PROJECT: 23-26- Sequoyah Bus Parking
Bid Date 3-28-2023 at 3pm

PROJECT NO. 21330

Narrative For Addendum #1

DATE: 3-21-2023

C503

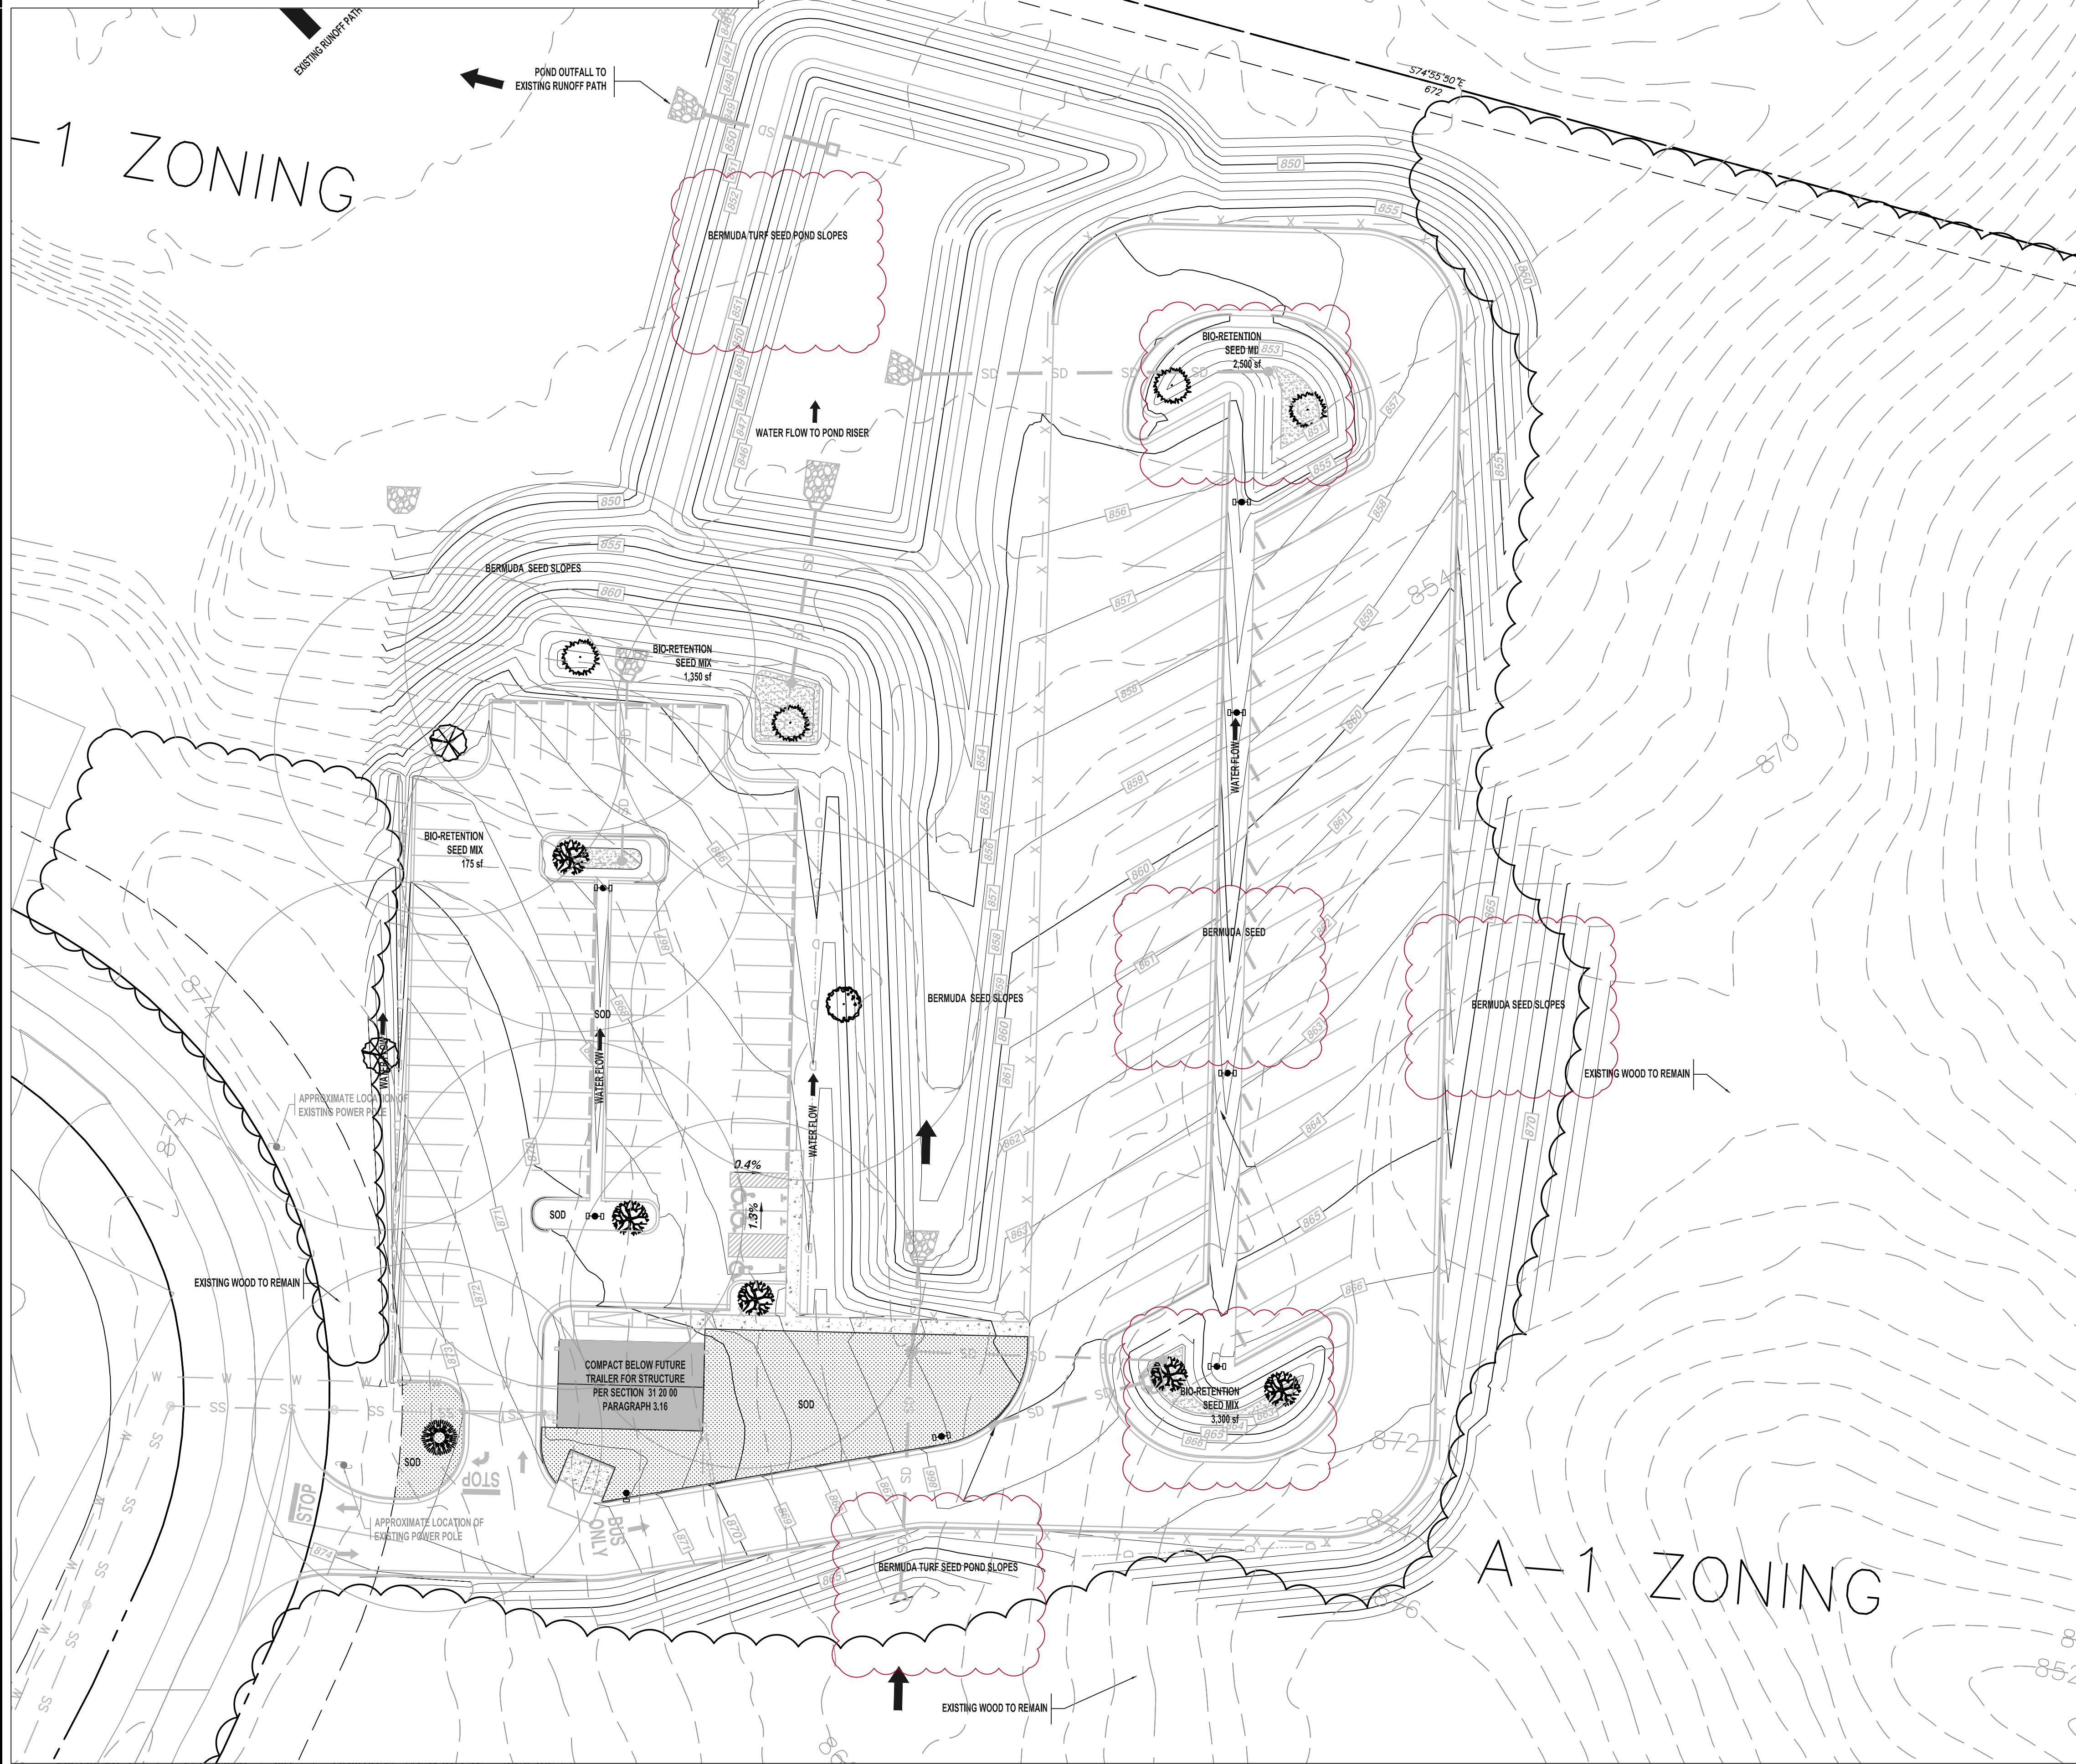
1. Adjusted background based on revised grading.

DRAWN: AE
 CHECKED: JP
 JOB No. 21330
 DATE: 03/03/2023
C600
 SITE LANDSCAPE PLAN

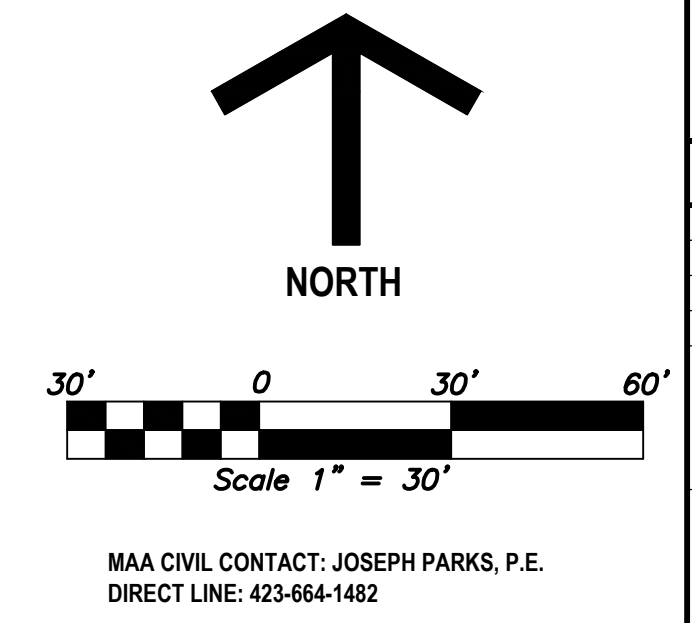
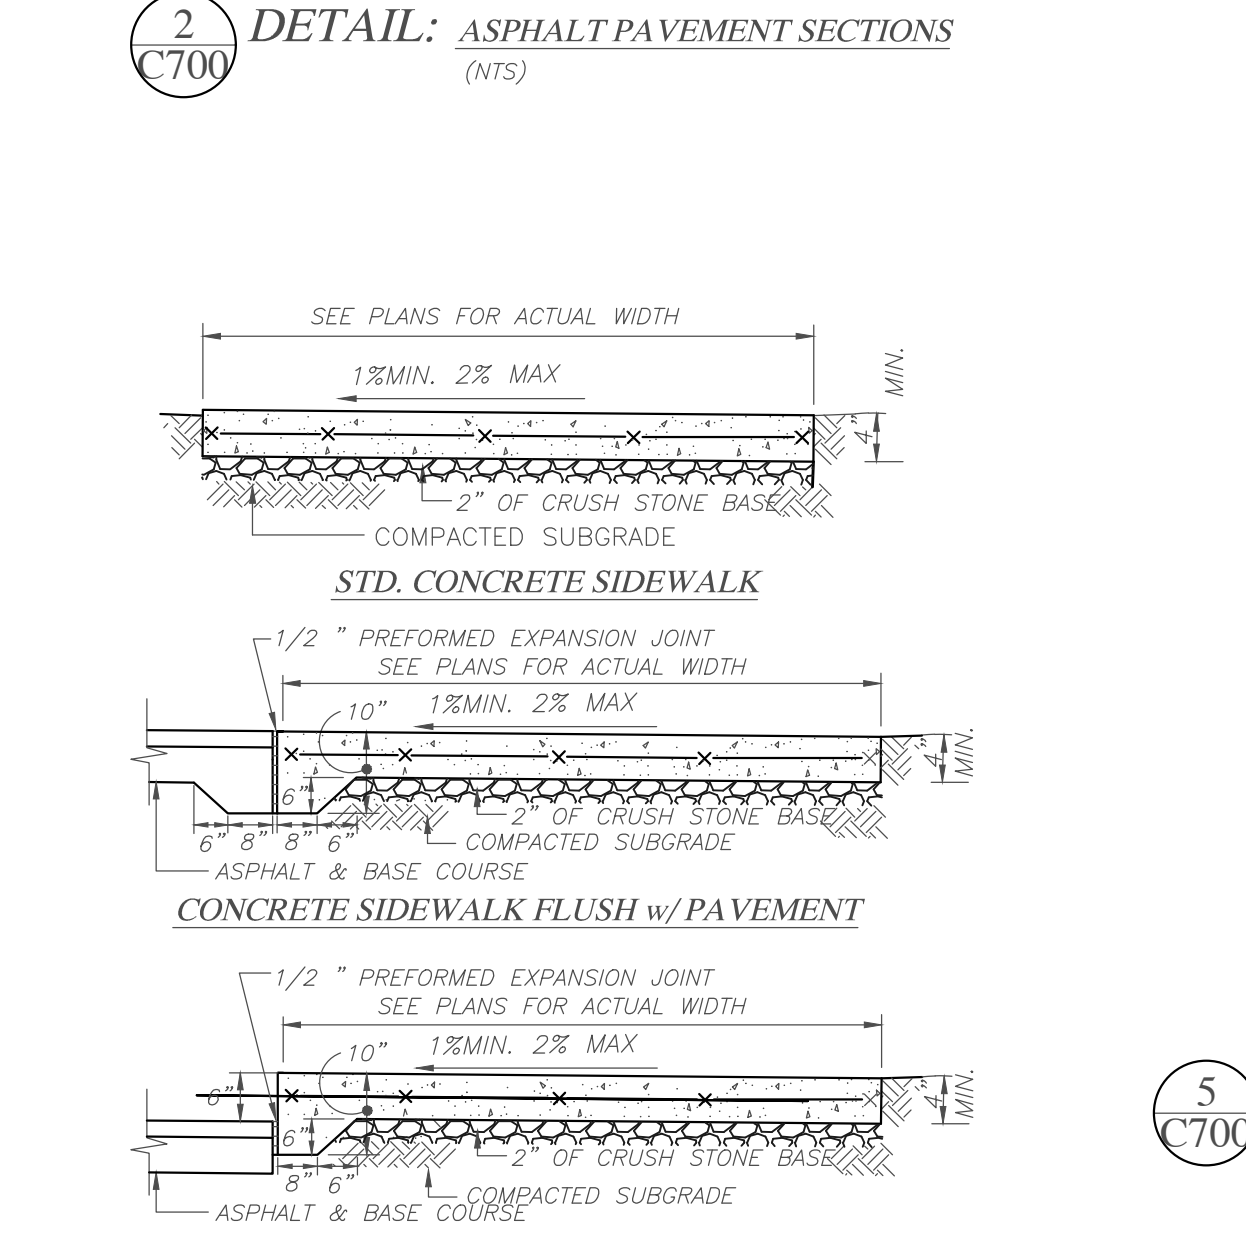
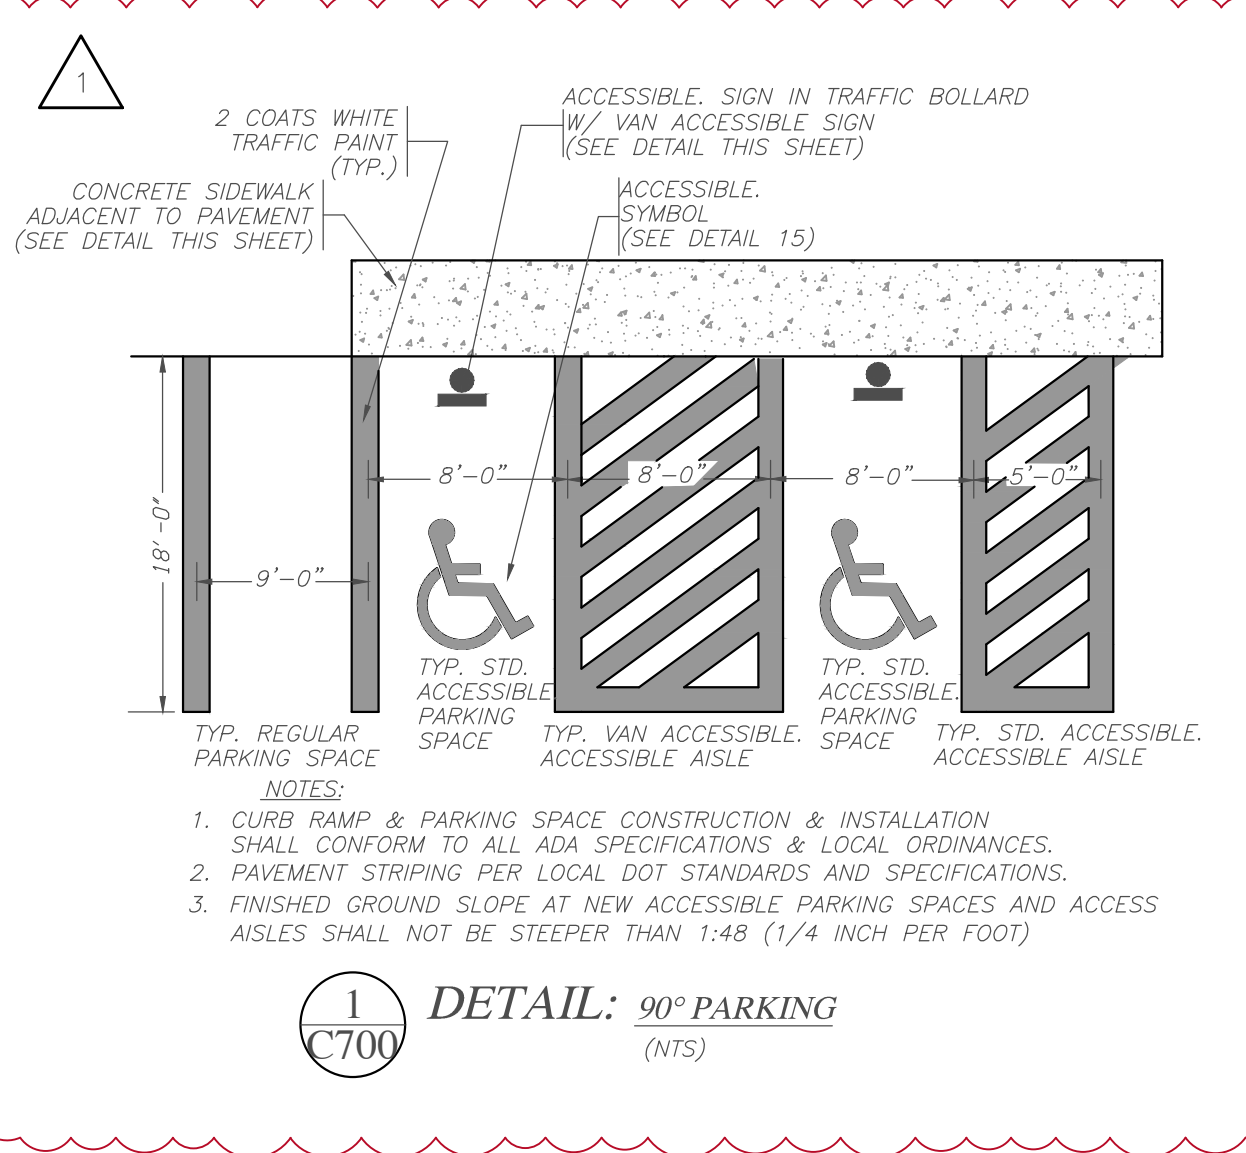
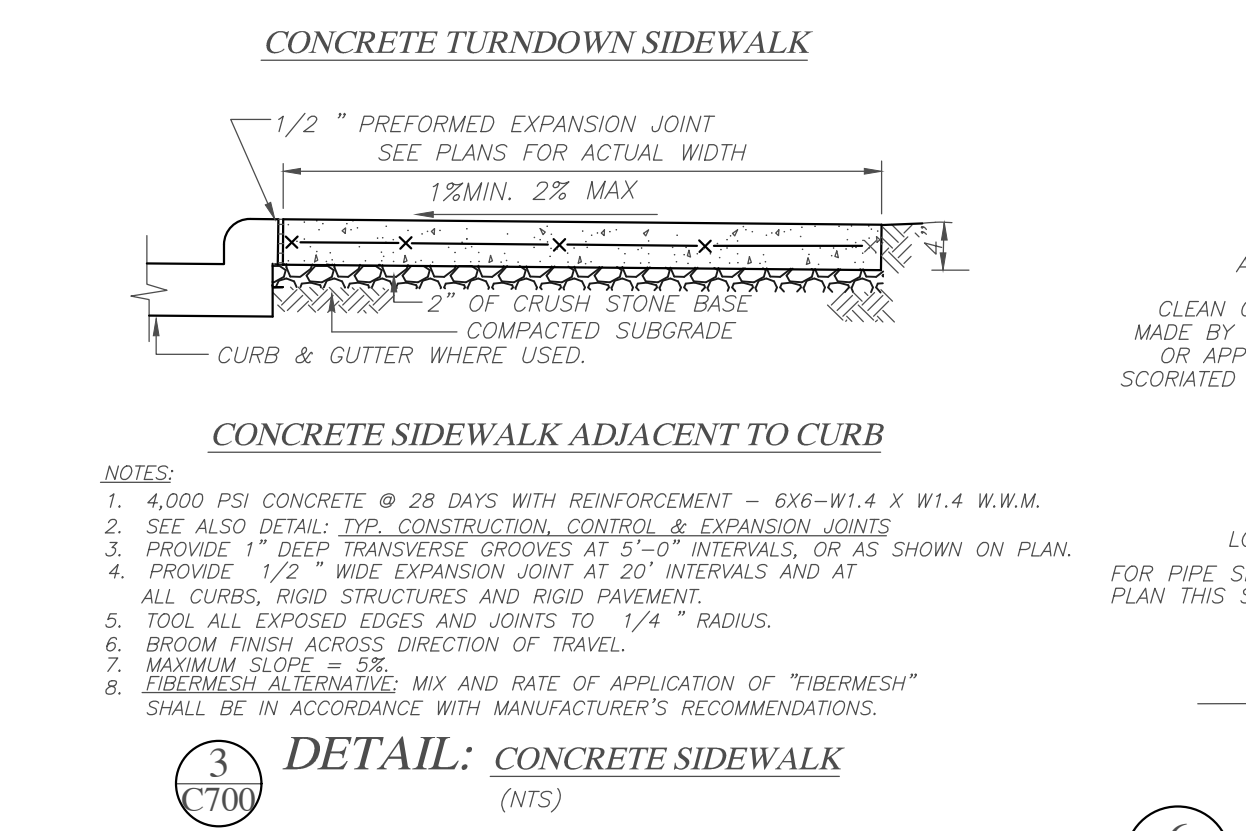
1. Listed bio-retention native seed, with seed area.
2. Listed slopes as Bermuda seed.
